## Traffic Commission Staff Report

August 22, 2011

- REQUEST:** Restrict Parking on one side of Pennington Road
- LOCATION:** Pennington Road (Between Airport & Museum Road)
- RECOMMENDATION:** Approval of No Parking on north side of Pennington Road

**PENNINGTON ROAD:  
BETWEEN AIRPORT & MUSEUM**

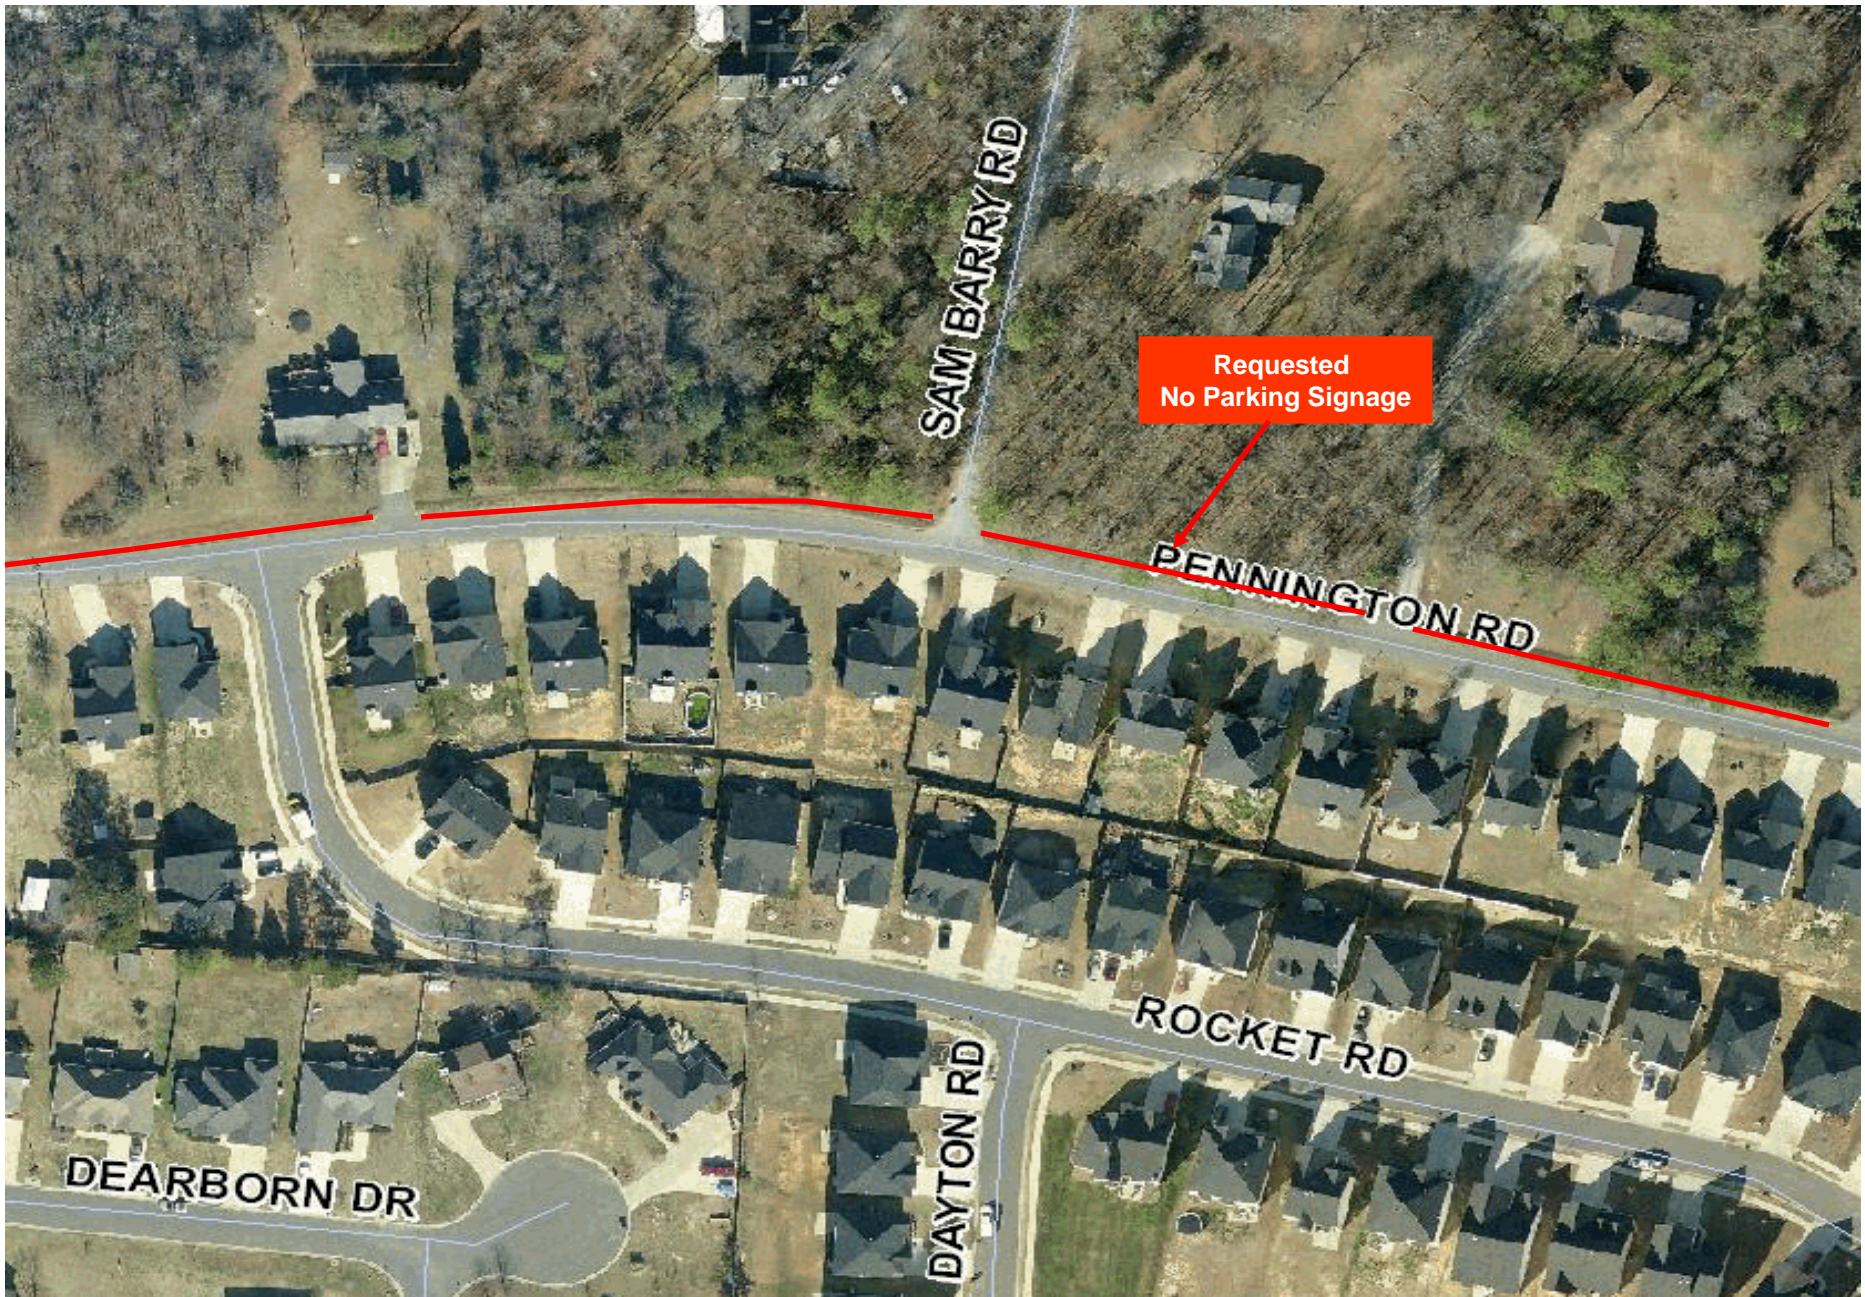
Therefore, at its regular meeting of July 28, 2011, the Traffic Commission voted unanimously to recommend that parking being restricted on the north side of Pennington Road **as reflected in the attached map.**

**RECOMMENDATION:** The Traffic Commission recommends that the Rock Hill City Council approve the request to restrict parking on the north side of Pennington Road between Museum & Airport Road.
